ID # CBR-2585

C106718 and/or C106818 DTC - VN (4) - AN (4) - PR

The purpose of this CBR is to provide support for fault codes C106718 and/or C106818.

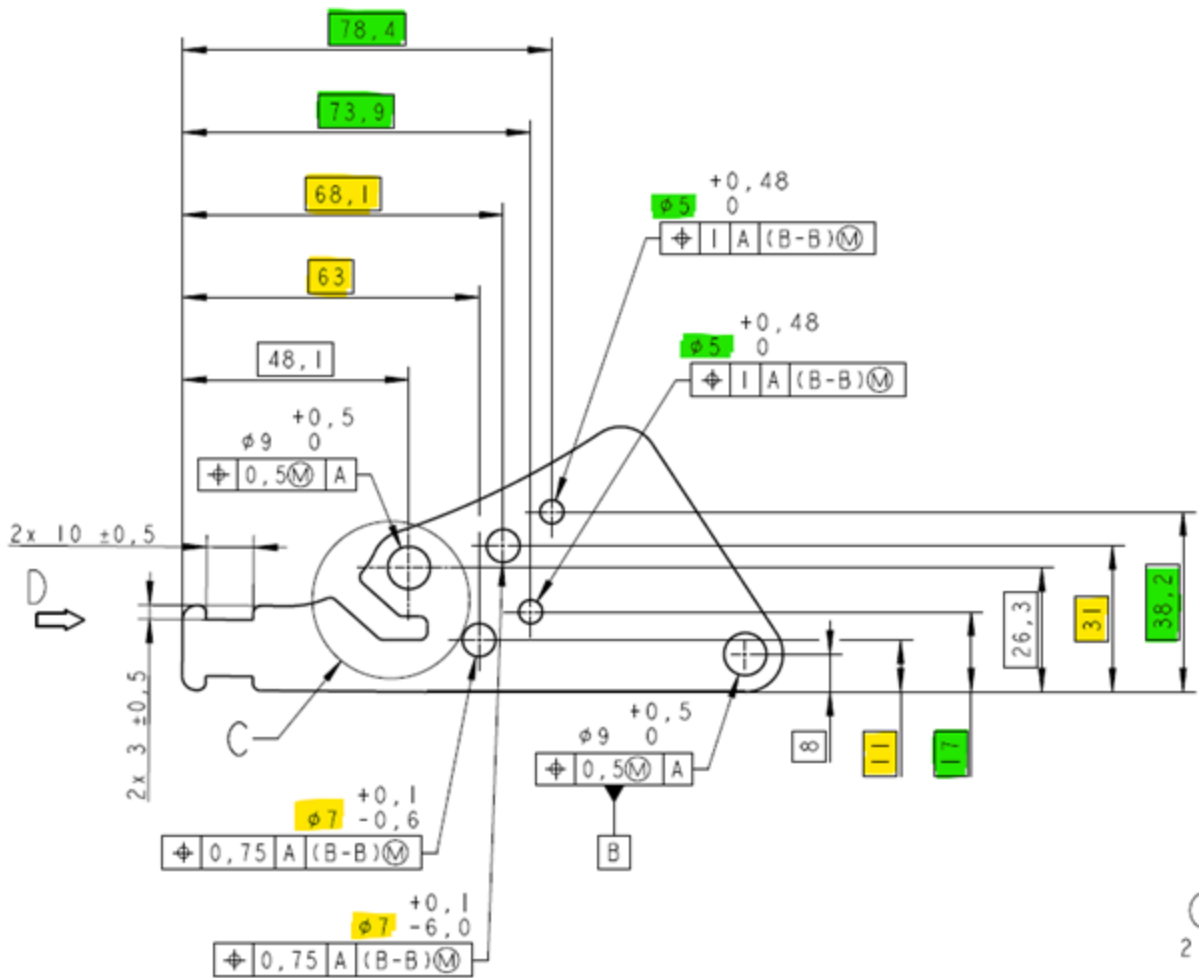
2. Use the drawing below to drill new holes for the harness routing.

Note: Yellow tags are to be drilled with 7mm drill bit
 Green tags are to be drilled with 5mm drill bit

3. Once the holes are drilled, reinstall on the truck.
4. Install harness to the bracket using the new holes. Ensure the harness is not contacting the shock.
